MEMO

To: Scott Blair, Senior planner
From: Ekin Sakin, Principal advisor, urban design
Date: 23 September 2014
Re: RMA 2024/576 137 Cambridge Terrace

This assessment is for a proposed 200-room, 11-storey hotel development in a single 42m high building in the Commercial Central City Business Zone, at the north corner of Worcester Street and Cambridge Terrace intersection.

Perspective - Main Entry Looking East

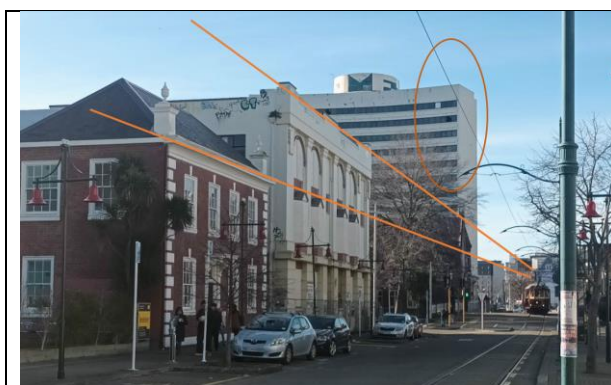
The images in Appendix 2 show the impact of large bulk at the street edge, in long perspectives of streets. The ex-Rydges hotel is a lived example of a disrupted (without transition) perspective of Worcester Street, especially when viewed from west. This proposal if goes ahead would have a similar impact on the Cambridge-Durham street perspective/ view shaft.

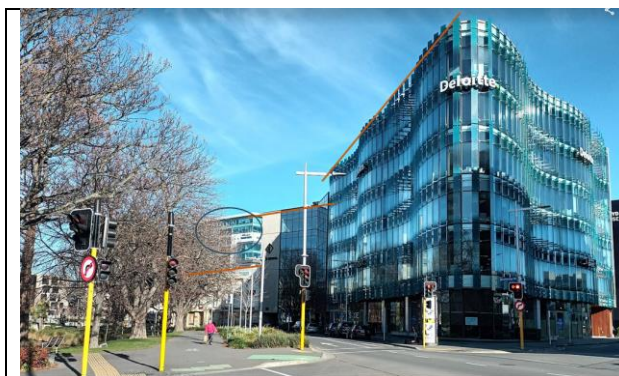
While not the exact same angle, we can see the disruption of the view shaft edge continuity with the proposed building's height at the street edge

Cambridge Street view shaft from north where the taller buildings are viewed in the background

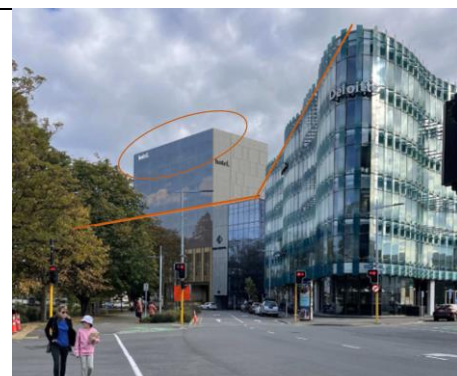
Cambridge Street view shaft from north where the proposed height of the building is

beyond the Worcester St corner which is defined by two lower heritage buildings.	significantly different to its neighbours which disrupts the edge and related perspective continuity.
--	---

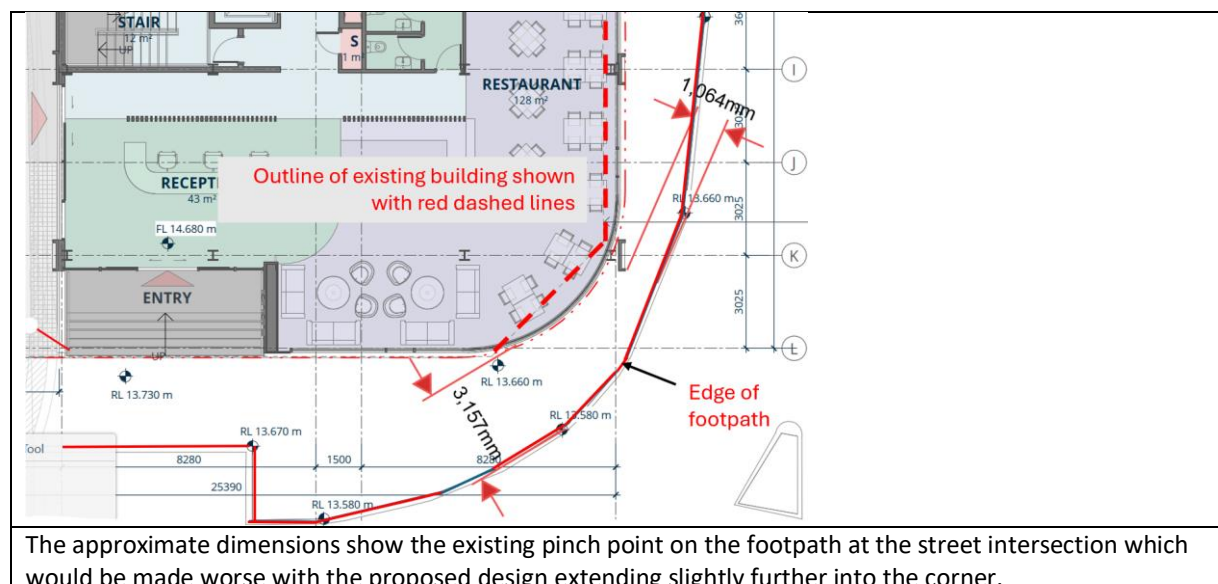
I consider that these two matters are not met.

The building design along Worcester Street includes a proposed generous main entry, a canopy and steps as well as glazing for visual connection between the interior and the street. Together, these balance the large gap created for vehicle access, acknowledging this gap also improves visibility of the adjacent heritage building. This elevation could be considered to just adequately meet the matters above. However the longer elevation along Cambridge Terrace does not meet the matter.

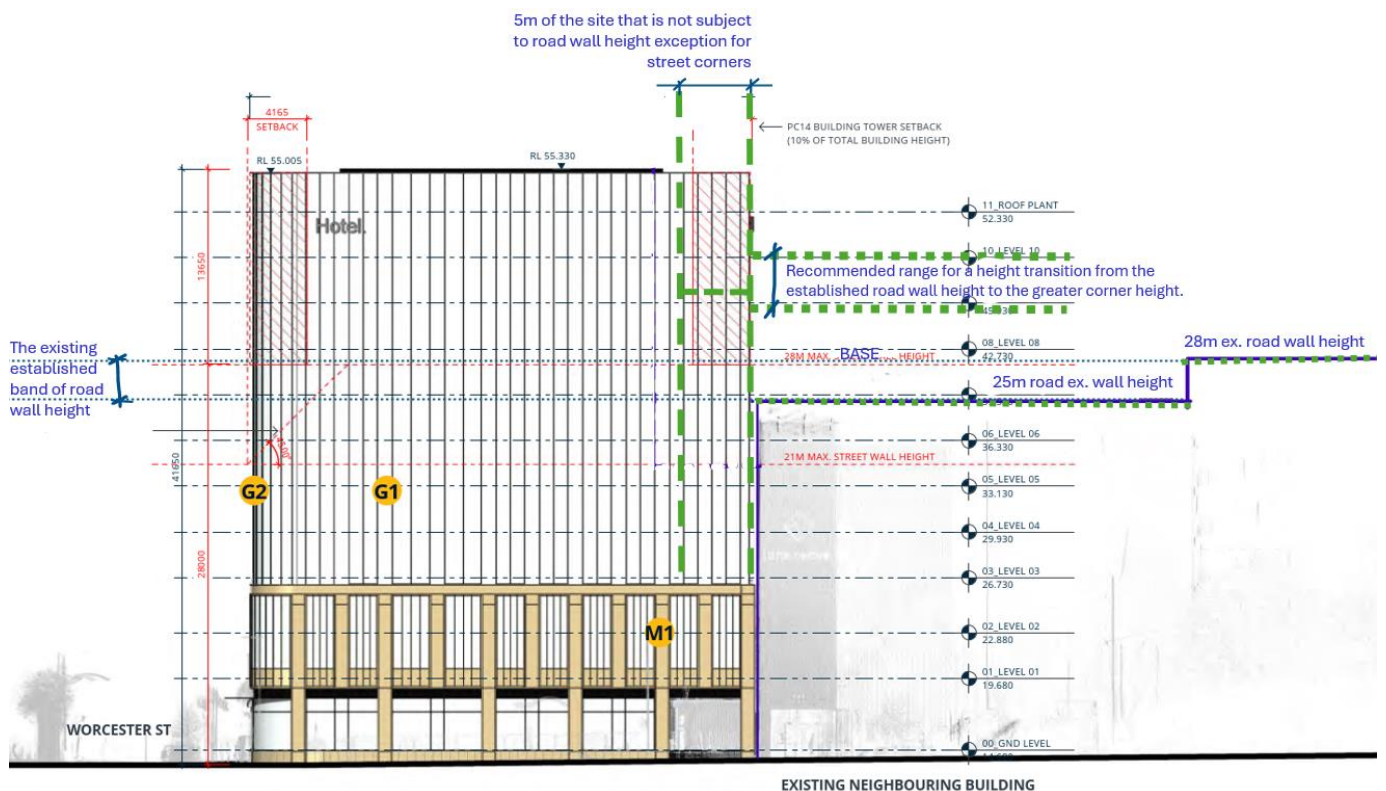
Presents a singular tall mass above the treeline.	Moderates the building height by differentiating the building base and the tower, not dominating the treeline when viewed from the Square. The tower part of the building reads as a building in the distance. The building base sets a relationship to the street edge that is more similar to the other taller buildings nearby, the Civic Offices and the Anthony Harper building.

Recommended Option 2

The 5m of the site that is not covered by the maximum road wall height exemption presents a visual and physical opportunity to reconcile the height difference between the proposal and the adjacent buildings on Cambridge Terrace.

Northern View Shaft Analysis Showing 137 Cambridge Massing

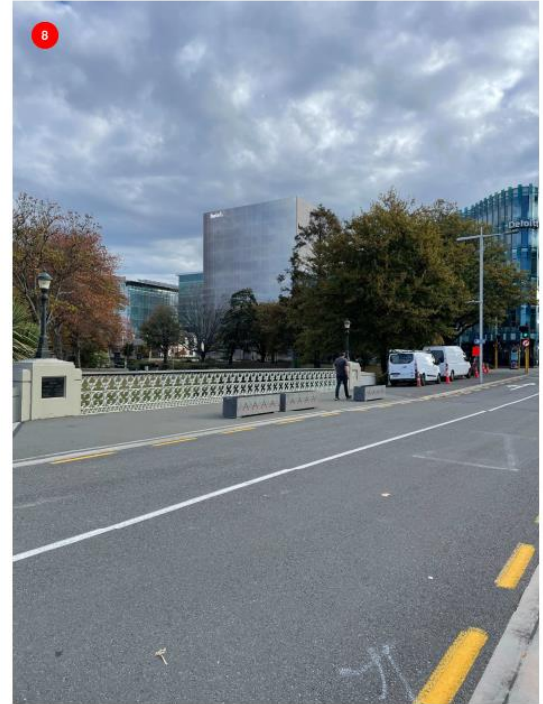
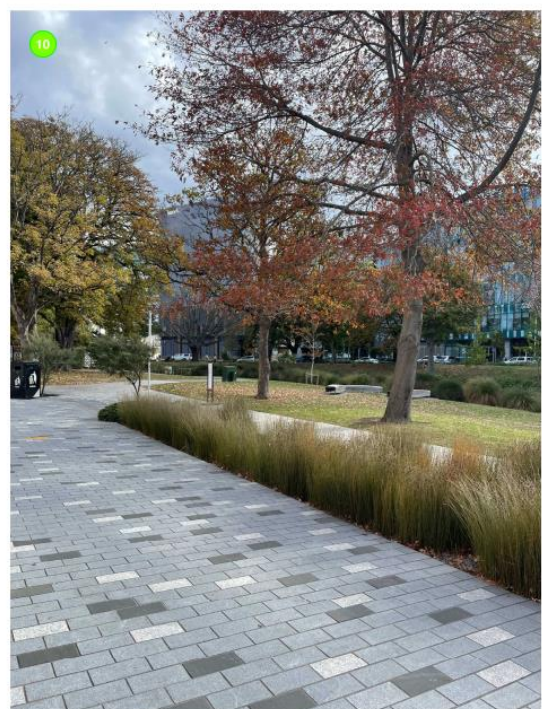
Selected photos from the application showing the potential disruption to the continuity along Cambridge Terrace showing the impact of the broken street wall continuity
